[Docket No. FAA-2013-0725; Directorate Identifier 98-CE-01-AD; Amendment 39-17690; AD 98-15-18 R1]

Airworthiness Directives; Maule Aerospace Technology, Inc. Airplanes

ACTION: Final rule.

Figure 1

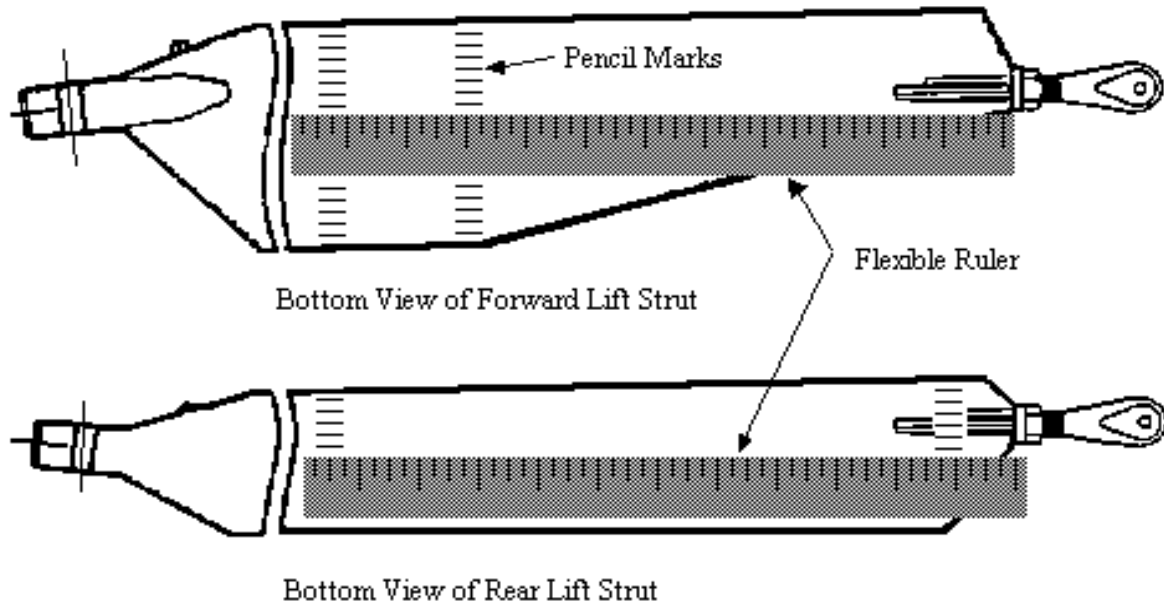
2. Using a flexible ruler, draw a 1/4-inch grid on the surface of the first 11 inches from the lower end of the strut as shown in Maule Air, Inc. Service Bulletin No. 11, dated October 30, 1995, as applicable. This can be done using a soft (#2) pencil and should be done on both faces of the strut. As an alternative to drawing a complete grid, make two rows of marks spaced every 1/4 inch across the width of the strut. One row of marks should be about 11 inches from the lower end of the strut, and the second row should be several inches away where the strut starts to narrow. Lay the flexible ruler between respective tick marks of the two rows and use tape or a rubber band to keep the ruler in place. See Figure 1.
